Bulletin

MODEL BENTLEY MARK VI

MODIFICATION.**REAR BRAKE EQUALISER.**

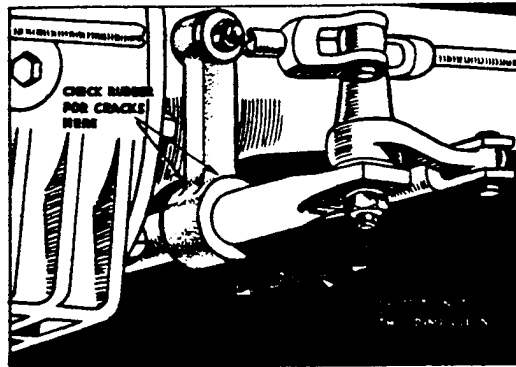
A certain number of cars were built with the rubber support of the rear brake equaliser fitted and positioned whilst in the chassis stage of production. When the body is mounted, the effect of its weight on the geometry of the rear suspension causes distortion of the support which may lead to fracture; repositioning of the support is therefore necessary in some cases.

The attached drawing and following procedure give the necessary information required for carrying out the examination and repositioning of the rubber support.

1. Disconnect the rubber support from the axle tube and flex it backwards and forwards so as to examine for cracks in the neck at the junction with the main boss. If there are any signs of cracks, replace with a new support.
2. Check that the rear face of the main boss is 2.275 ins. from the centre of the rear brake equaliser bolt, and reposition if necessary.
3. Paint the letter 'E' on the rear face halfway down the rubber leg after examination and repositioning.

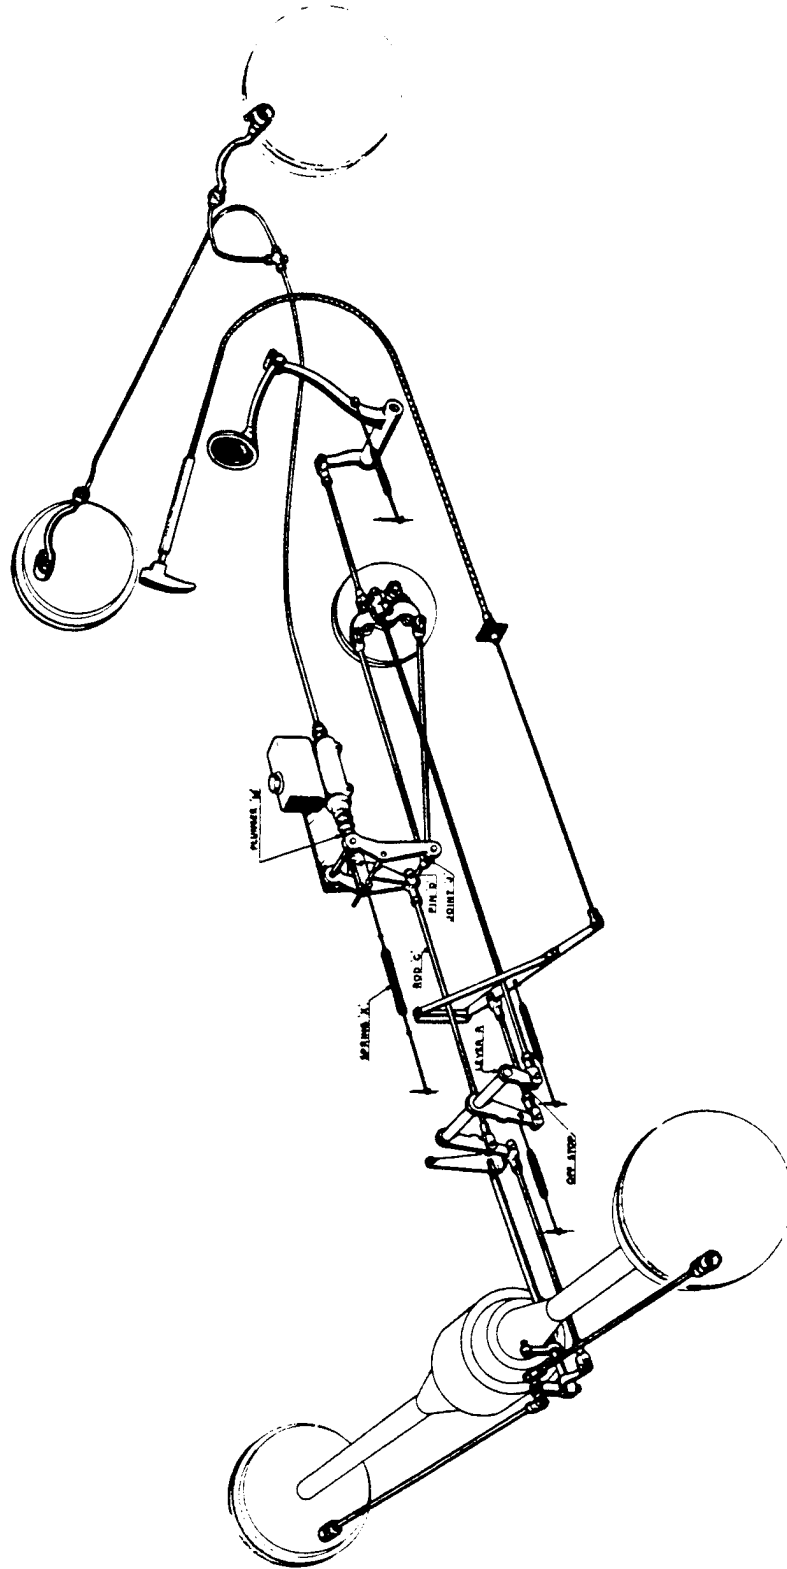
A modification is introduced to reduce a mechanical noise that can more accurately be described as a "clonk" from the brake linkage which may occur on application of the brakes.

In many cases, the origin of this noise has been traced to excessive free travel between the plunger and piston of the brake master cylinder, and adjustment of the brake linkage as described hereunder, has in certain instances effected a noticeable reduction of the noise.

The attached drawing shows the linkage involved in carrying out this adjustment:-

1. Ensure that the rear brakes are in the OFF position and that the lever 'R' is against its OFF stop.
2. Remove the master cylinder pull-off spring 'X' and the clevis pin 'D'
3. Adjust the rod 'C' so that the joint 'J' has zero to .050" free travel before the plunger 'M' contacts the master cylinder piston.
4. Tighten the locknut on the rod 'C'. Replace the clevis pin 'D' and the master cylinder pull-off spring 'X'.

FIG. 1.

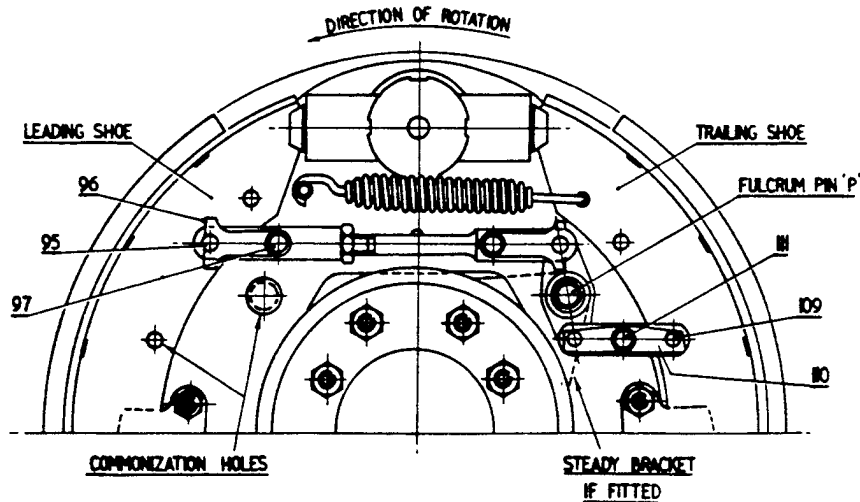
Instances have occurred in service with the Bentley Mark VI, where the front brakes have failed to release properly after application. This "Spragging" of the front brakes is due to an excessive self-servo action of the shoes, and manifests itself by a locking of the brakes even after the foot pedal has been released. In all such cases, the following modification should be carried out.

REMOVAL OF EQUAL WEAR LINKAGE (FIG.1).

- (a) Remove setscrew and spring washer (111) and the locking plate (110) and by easing the load from the pull-off spring, withdraw pin (109).
- (b) Remove setscrew and spring washer (97) and locking plate (96) and withdraw pin (95).
- (c) Remove equal wear linkage from fulcrum pin (P) complete.

FIG. 2.

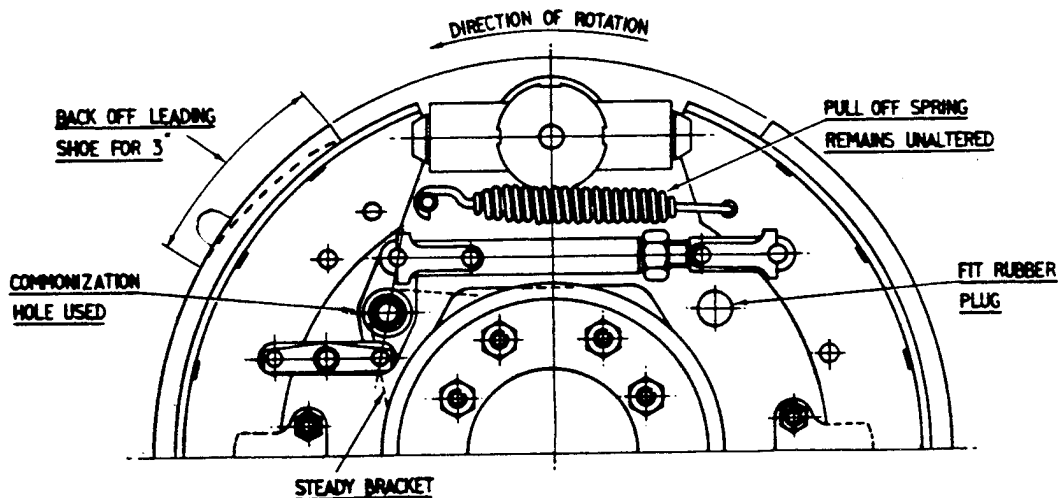
- (a) Replace the existing push rod and jaw of the equal wear assembly with the strengthened parts Nos. RG-6045/6 and nut K-4010/Z.
NOTE: If these parts are not available, the existing push rod and jaw may be used, but should be replaced at the first opportunity.
- (b) Invert equal wear linkage assembly, and replace on fulcrum pin (P). (The short link should now be to the front of the car, and will line up with the lowest of the three top holes in the leading shoe, and the push rod will be to the rear and will line with the second hole from the top in the trailing shoe).
- (c) Replace pin (109) in the short link, locking plate (110) and the setscrew and spring washer (111).

FIG. 3.

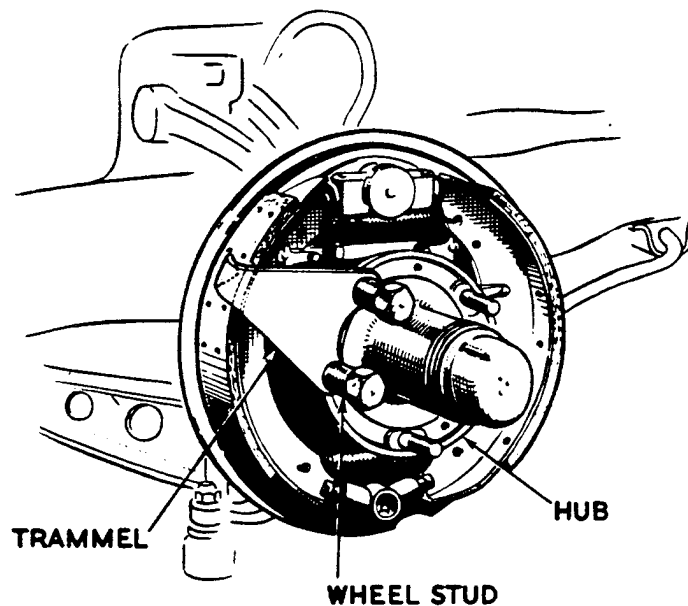
- (a) From a piece of light gauge steel, make up a trammel as shown in (FIG.3) to fit over two of the wheel studs on the hub, and bend the pointer to touch lightly on the face of the brake linings.

FIG. 1. FITTING OF UNDERSHIELD.

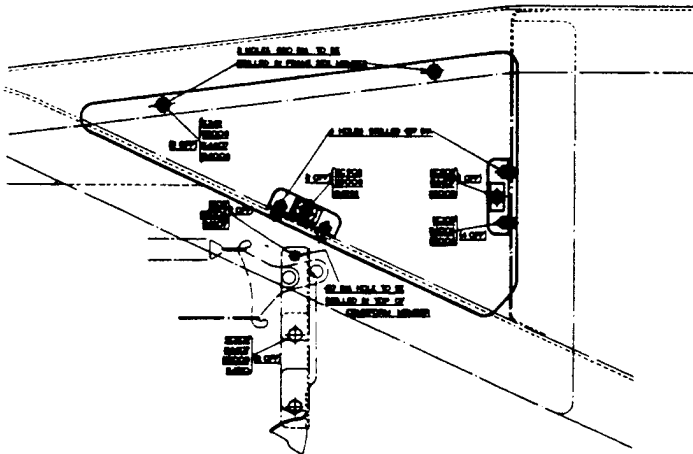
bolt holes in the lower flange of the frame side member, also for the two supporting brackets as shown in Fig.1. Drill the two 0.250" dia. bolt holes in the frame side member.

1. Place the car over a pit, or elevate on a suitable hoist.
2. Remove the battery.
3. Remove the existing right-hand rear undershield immediately below the servo unit.
4. Offer up the new undershield from below the chassis and cover the triangular gap formed by the frame side member and cruciform member forward of the battery container. Mark off the relative positions for the two

FIG. 2. BAFFLE PLATE.

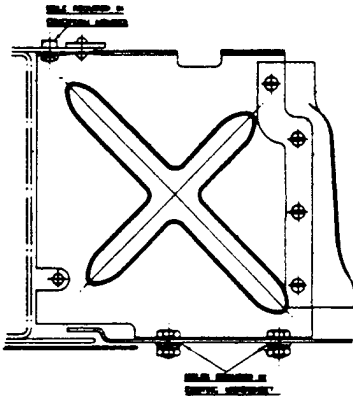
8. Fit the rubber protection piece to the baffle plate as shown in Fig.2. Both the rubber and the retaining strip should be fitted on the ENGINE side of the plate, with the nuts for the securing screws on the obverse face.

FIG. 1 FITTING OF UNDER-FRAME COVER PLATE.

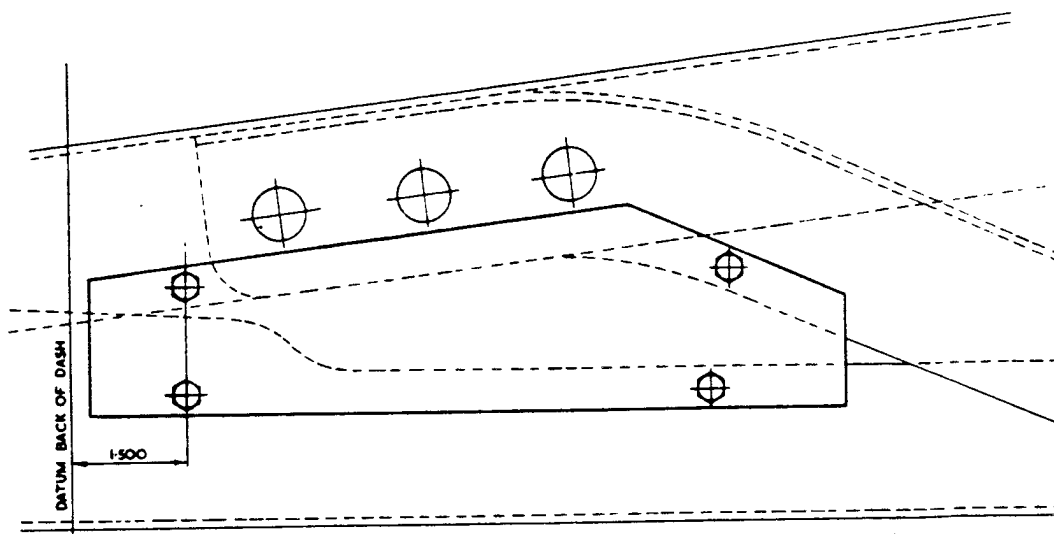
1. Fit the under-frame cover plate (RF-6209) as shown in Fig. 1.
 - a) Offer up the plate, and mark off the relative positions for the four retaining setscrews.
 - b) Drill the four holes 0.1562" dia., and then tap 2 BA (31 T.P.I. R/H).
 - c) Fit the cover plate.

FIG. 2. METHOD OF FIXING COVER PLATE OVER HAND-HOLE.

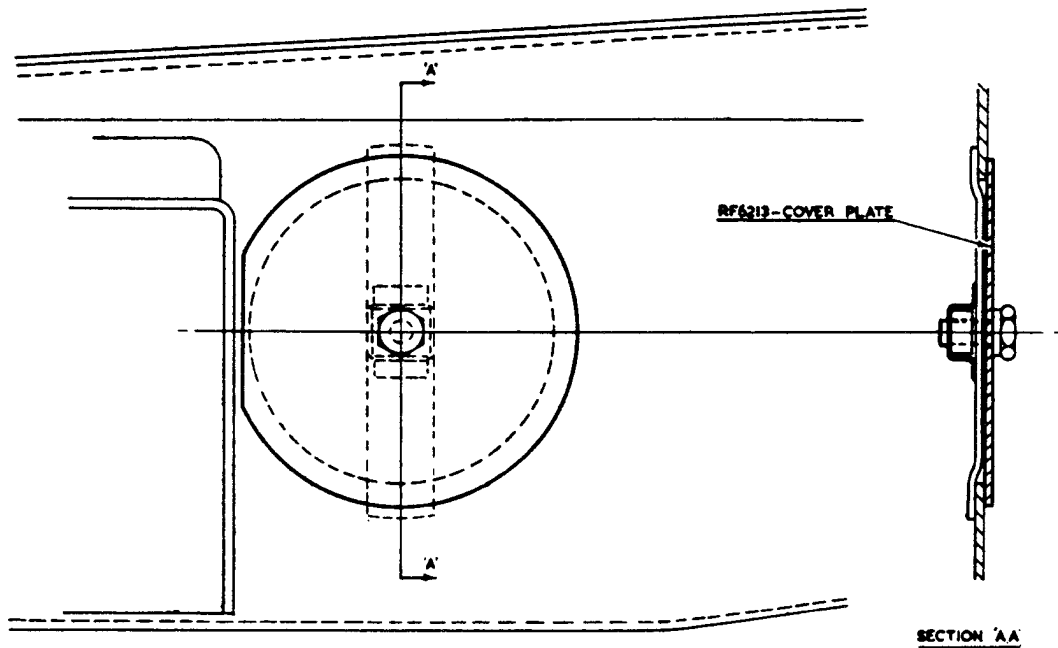
2. Fit the hand-hole cover plate (RF-6213) as shown in Fig. 2.

FIG. 1. DIAGRAM - SETTING INSTRUCTIONS - FRONT BRAKES.

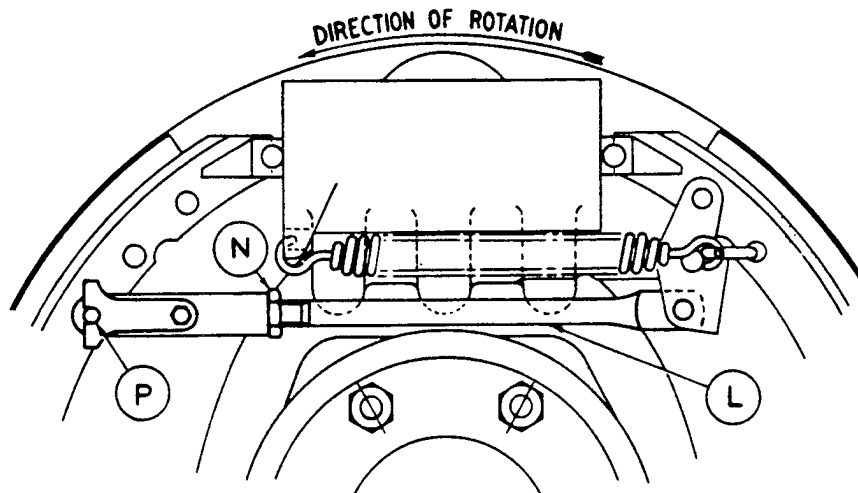
- (i) Build up the brake complete, but do not fit the locking plate for pin P, Fig. 1, or lock the nut N. For an initial setting, the link L, should be adjusted to 7.375" (187.3 m/m) between the pin centres.

- (iv) Fit the brake drum to the hub. If the drum cannot be fitted over the shoes, lengthen the link L, until it can. This is most easily done by first detaching the pull-off spring, when the pin P can easily be withdrawn.

- (vi) If more than 15 "CLICKS" are obtained, remove the drum, shorten the link L, and try again. If less than 9 "CLICKS" are obtained, lengthen the link L, and try again. One complete turn of the jaw on link L, corresponds to about 3 "CLICKS" of the adjuster.

FIG. 2. FINAL POSITION FOR
MODIFIED SUPPORT.

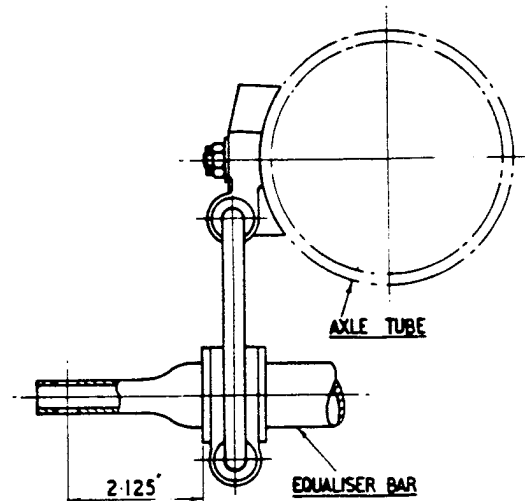
- (3) Thread on the new support assembly from the front end of the equaliser bar, and slide the assembly along the bar until the outer face of the silentbloc bush is exactly 2.125" distant from the centre of the bolt hole at the rear of the bar (See Fig. 2. above). Due to the interference between the rubber bush and the bar, it is recommended that some form of lubricant, e.g. French chalk or soap, is used to facilitate sliding the assembly along the bar.
 - (4) Fit the upper bracket to the existing stud on the axle tube, replace the existing plain washer (distance piece), and then secure by means of the thinner castellated nut provided, locking this by fitting a new 1/16" split pin. Reconnect the equaliser bar.
- NOTE: - Constructional variations in the rear axle tube may result in

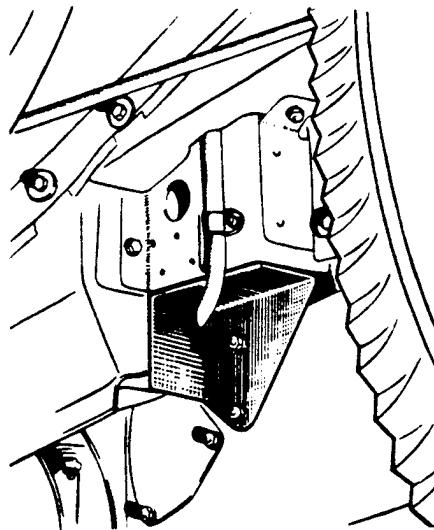
Investigations have shown that the deletion of the dashboard side mounting brackets (Service Bulletin BB-115) renders it possible in wet weather for water to reach the servo motor and gear change mechanism through the gap between the front of the body and frame member.

To obviate this, additional protection for these components has been provided on current chassis in production from B-229-LH onwards, and Retailers are requested to take the necessary retrospective action to ensure that this is also incorporated on earlier model Standard Saloons in their areas on which these brackets have been deleted. (N.B. The deletion of the dashboard side mounting brackets on Standard Steel Saloons was first effected in production at Chassis No. B-153-JN. The chassis numbers involved are therefore from B-153-JN to B-227-LH inclusive, plus all other cars on which these side mounting brackets have been removed in service).

This protection consists of a flanged plate (Part No. RF-8881) which is fitted in the position originally occupied by the lower dash mounting bracket on the right-hand side of the chassis as shown in the above illustration. The existing bracket mounting holes in the frame are used for fixing the plate, and it should be noted that when this is finally fitted, there must be a clearance of approximately 0.187" between the top and rear flanges and the dash and body respectively. The two bolt holes in the plate itself are of a slightly larger diameter than the retaining bolts supplied thus permitting a certain degree of adjustment when fitting the plate.

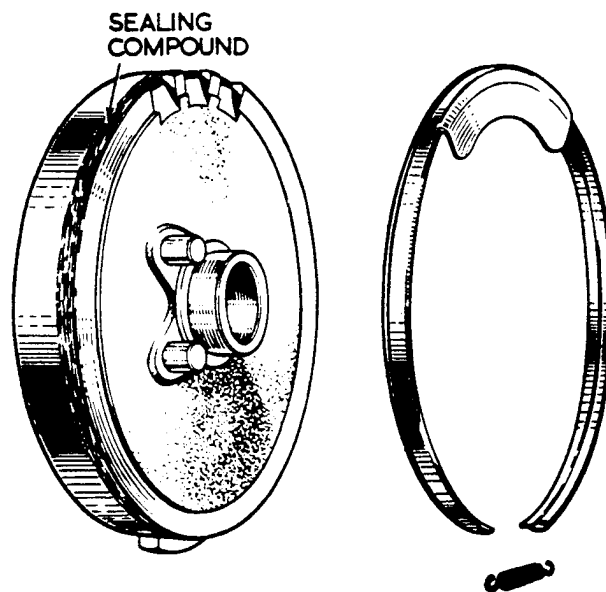
In order to prevent the possibility of oil seepage into the servo motor, the joint between the flange of the spring backing plate and the pressure plate is being coated with "Wellseal" on current production. "Wellseal" is a sealing compound with a rubber solution base which remains soft and pliable when dry.

Retailers are advised that, whenever a servo motor is removed for overhaul or other reason, it should be treated with "Wellseal" or an equivalent compound. After assembling the servo in the usual way, but before fitting the protector ring, the compound should be applied with a thin brush as shown in the illustration.

FIG.1. EXPLODED VIEW OF SERVO MOTOR.

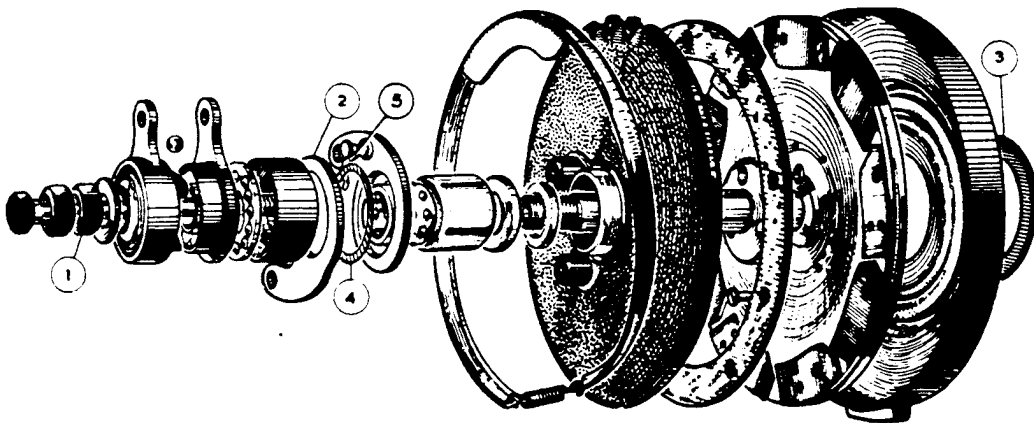
A corrugated washer, Part No. R.5037, has been developed to overcome cases of servo judder on brake application. The washer is fitted between the brake actuating levers in place of the plain washer GB.5083 and effectively damps the servo output to prevent minor fluctuations in the brake linkage from developing into judder.

1. Adjusting Nut.
2. Brake Actuating Levers.
3. Ferodo Washer (To be replaced by R.5285 if necessary).
4. Plain Washer GB.5083 (To be replaced by R.5037).
5. Spring Clip (To be removed).

On all early series cars the corrugated washer can be fitted without further modification, except from approximately B-152-UM onwards when the loading of the servo motor spring back plate was increased from 25 to 40 lbs. With the heavier load spring plate a thinner servo drive sealing washer R.5285 must be fitted in place of the Ferodo washer between the spring plate and the gearbox. This ensures that the combined end thrust of the spring plate and corrugated washer is not sufficient to prevent the brake actuating levers from returning to their off-stop on releasing the brake pedal.

FIG.2.
A. Brake Actuating Lever. B. Servo Washer (R.5037).
C. Feeler Gauges.

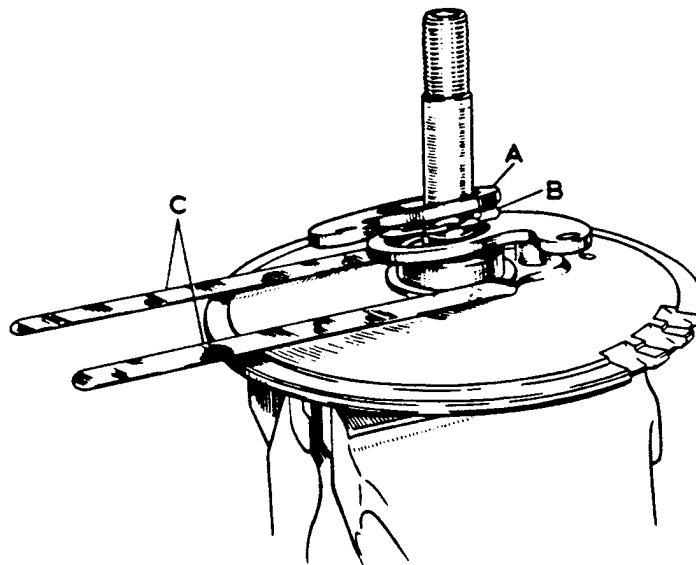
and the flange on the servo shaft. The servo is then placed in a vice as shown (Fig.2), the corrugated washer fitted into position, and the servo assembled. The adjusting nut is tightened fully home, thus compressing the corrugated washer.

FIG.3.

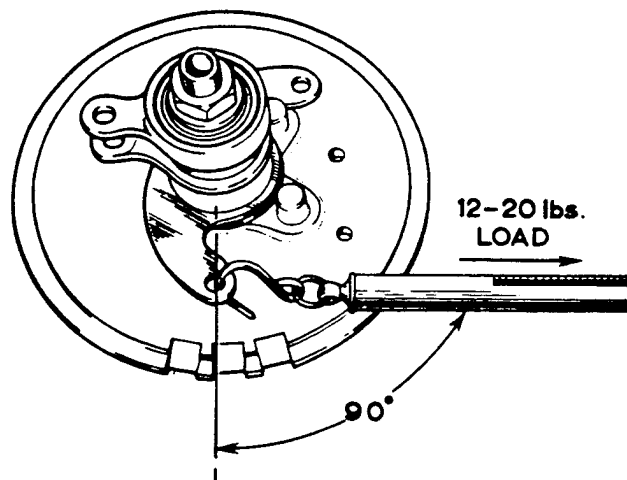
A spring balance is then attached to the brake actuating lever and the poundage figure accurately taken; this must be between 12 and 20 lbs (Fig.3).

If the figure is too high, the adjusting nut must be slackened, two feeler gauges (approximately 0.002" for every 5 lbs in excess poundage) placed between the lower brake actuating lever and the servo pressure plate and the adjusting nut tightened fully once more. This will compress the corrugated washer still further, so that when the feeler gauges are removed

FIG.4.

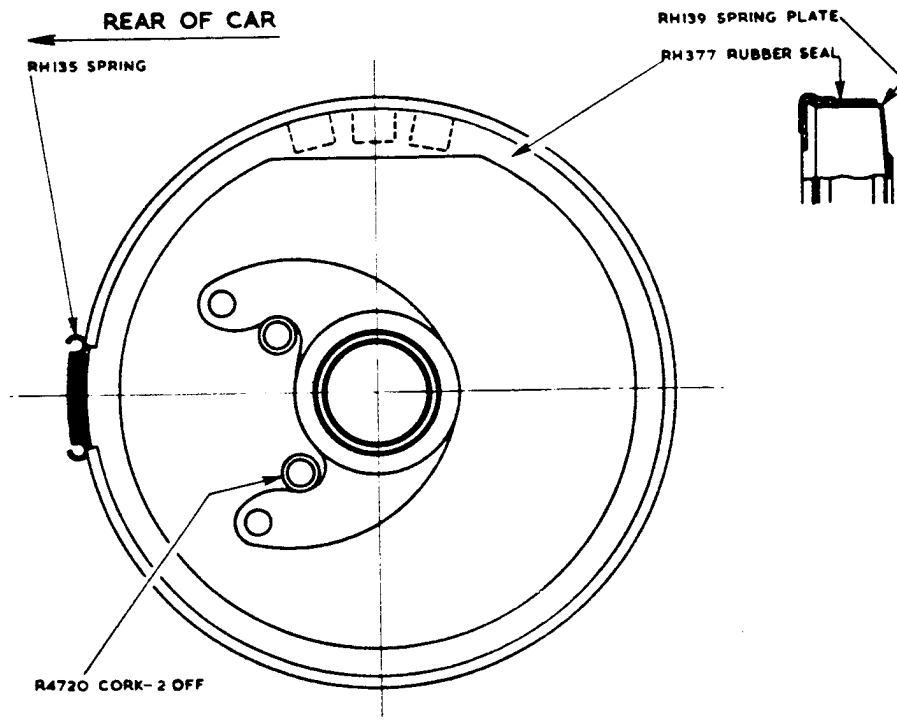
The servo spring plate, lined plate, pressure plate and servo main shaft are to be put together so that after the seal has been fitted the servo can be completely re-assembled and re-fitted, (Fig.4).

the edge of the plate, not by pulling on the outer edge of the seal as might be expected, but by pulling on the inner diameter; this prevents distortion of the outer periphery. The rest of the seal is then eased into position, still pulling on the inside diameter until the inner periphery fits closely into the spigot running around the upper face of the pressure plate. The whole seal is then to be eased into position finally and retained by the protector ring which must be fitted with the lower rate spring RH.135, otherwise it will not fit over both the seal and the pressure plate. The spring is to be positioned towards the rear of the car and not to the lowermost position as was usual. On certain servos the ends of the brake actuating lever operating pins will be open; these must be sealed with two corks (Fig.4).

Fig.2. Section-Return valve assy.
master cylinder.

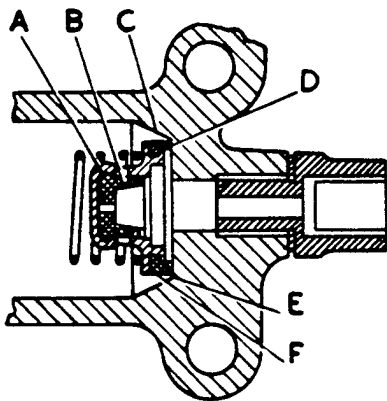
There have also been cases of ingress of air into the system due to non-sealing of the rubber valve washer 'F' Fig.2. against the face 'D' at the outlet end of the cylinder. The sealing lip 'A' Fig.1. of the rubber cups in the front brake expanders is normally held in firm contact against the bore of the expander by a residual hydraulic pressure of about 12-14 lbs.per sq/in. created by the spring loading of the return valve illustrated in Fig.2. Should this valve fail to maintain the hydraulic pressure, air may enter past the cups of the expanders owing to the comparatively low pressure exerted by the cups themselves against the bore.

Examination revealed that the primary cause of the valve washer 'F' not seating correctly, was due to the diameter of the face 'D' of the master cylinder being too small, causing the valve washer to make heavy contact with the rough un-machined tapered sides 'C' of the cylinder resulting in excessive wear and distortion of the valve washer.

- (i) Fit a new rubber washer 'F' (RG-7043) and a rubber cup 'B' (CD-130) to the valve body 'A'. Place the coil spring on to the valve and enter into the cylinder and check that the valve assembly has a diametrical movement of approximately 0.020" (0.50 m/m) to ensure that there is sufficient clearance between the outer diameter of the valve washer at point 'E' and the cylinder.
